Medical Center of Aurora
South Campus - Cath Lab Addition

CITY OF AURORA
BUILDING DIVISION
APPROVED AS NOTED
DATE APPROVED APR 17 2009

City of Aurora Plan Review
Project CATH LAB Addition
Address 1501 S Potomac
Contractor JE Dunn
RSN 458346
Permit Number 09-387421-LT
Plan Location

City of Aurora Plan Review
Occ./Const. Type I-2 / 1-A sprk
Code 2006 IBC S.F. 4535
RSN 458346
Permit Number 09-387421-LT

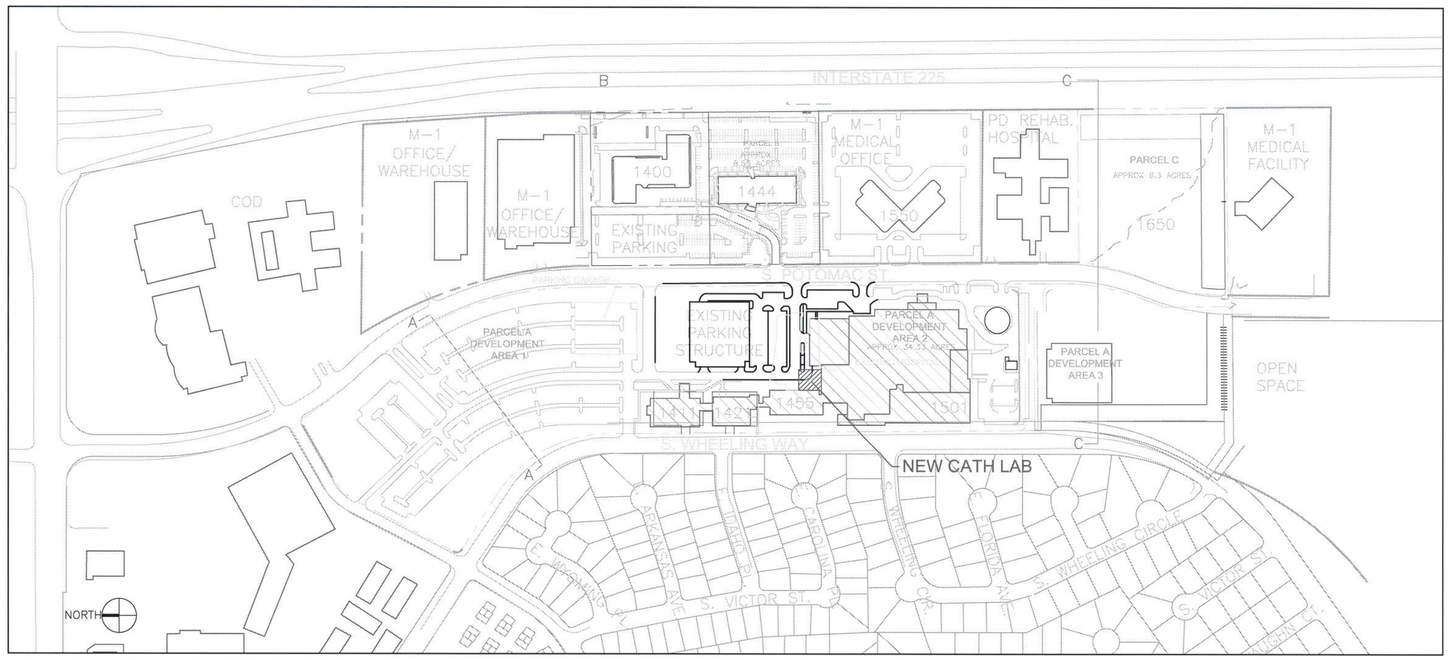
Provide U.L. Class _____ minimum rating fire extinguishers at a maximum 75'-0" travel distance prior to the Certificate of Occupancy issuance (2006 IFC Table 906.3[1] and 2002 NFPA 10)

Consultation for fire extinguisher placement is available upon request. Call 303-739-7420 prior to final Life Safety inspection to verify proposed locations.

ARCHITECTURAL ROOF PLAN

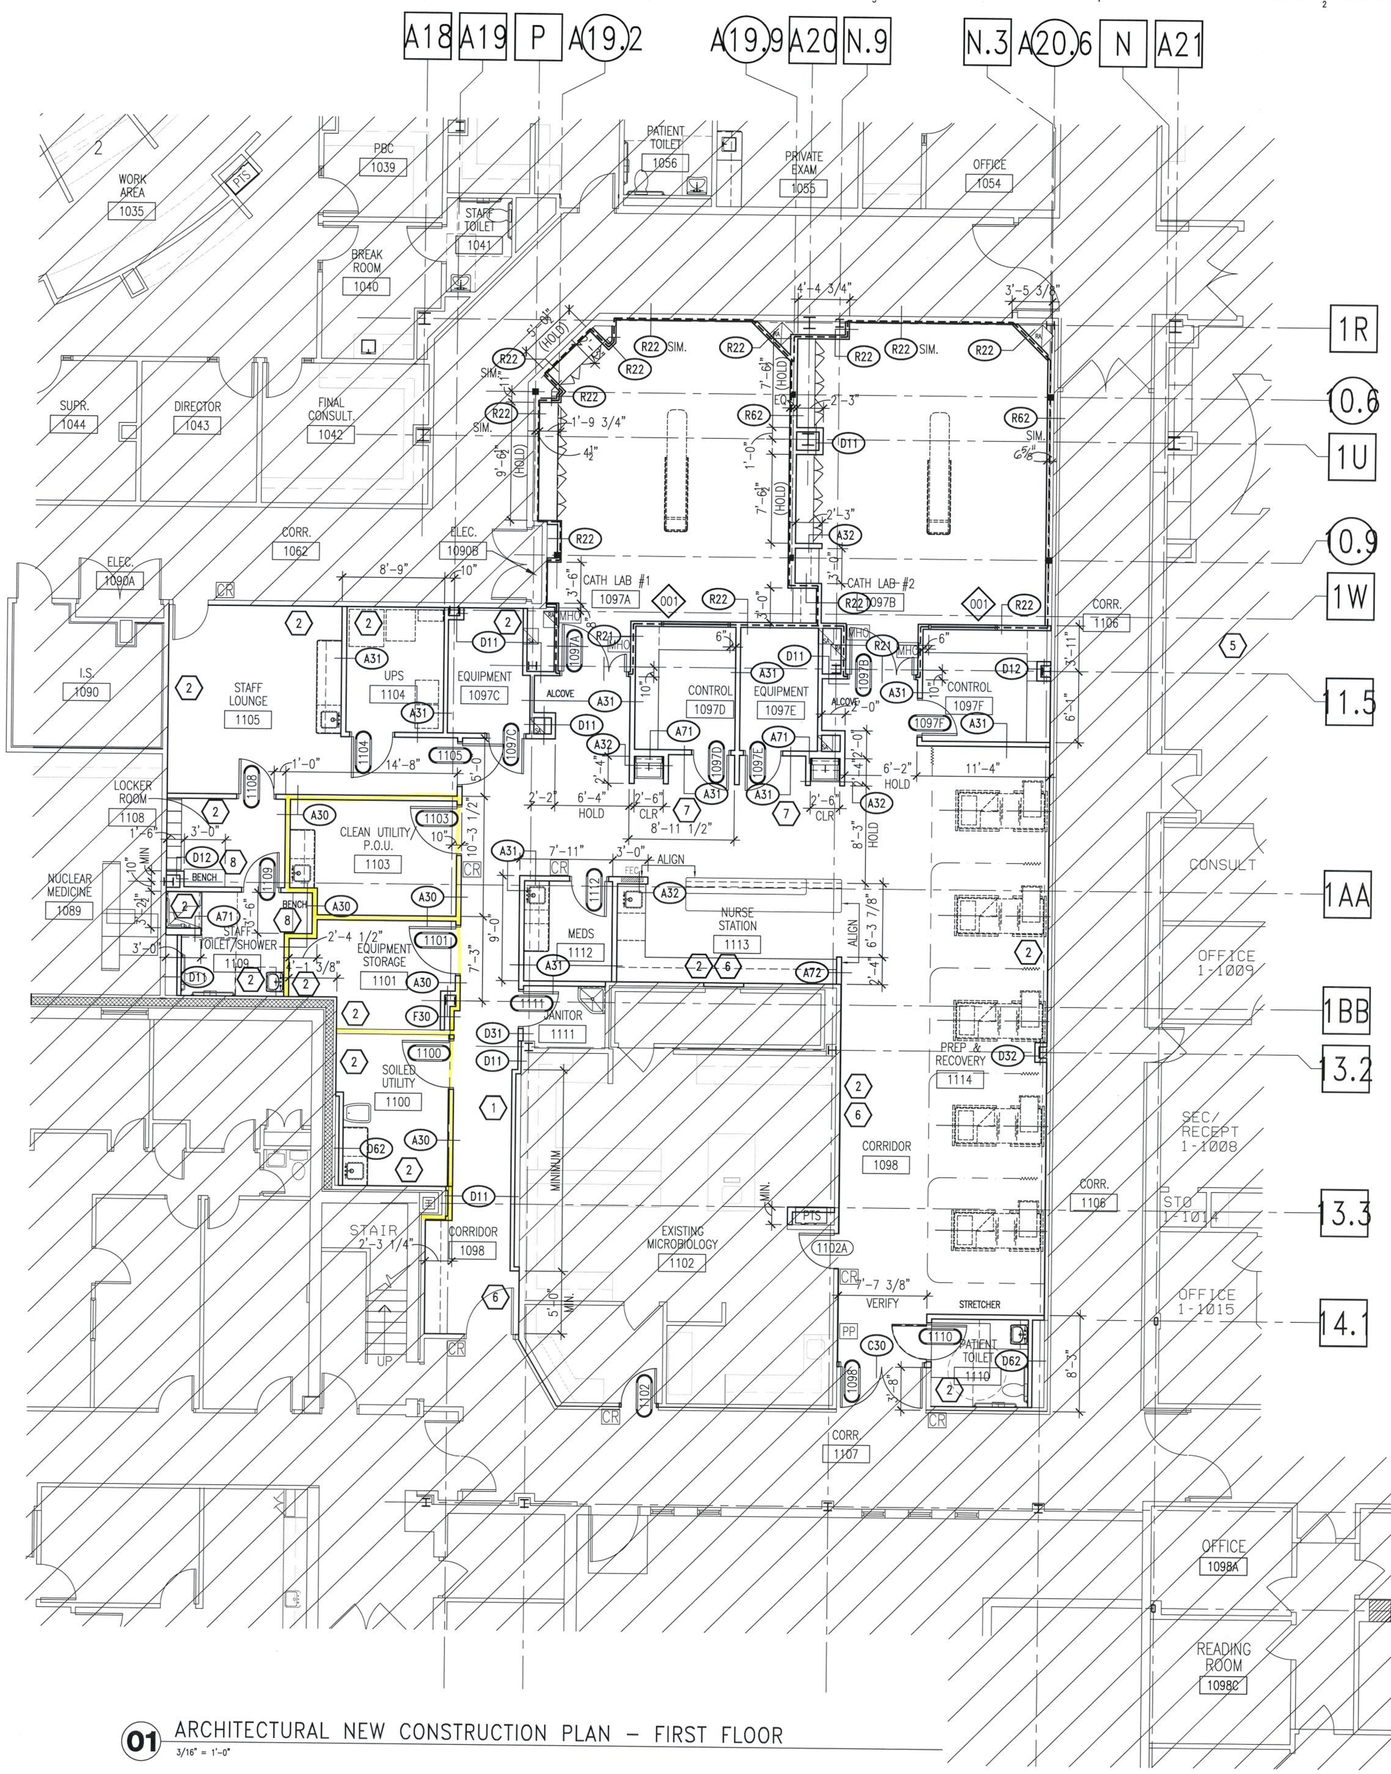
Refer to note on City-approved site plan for required screening method of rooftop mechanical units.
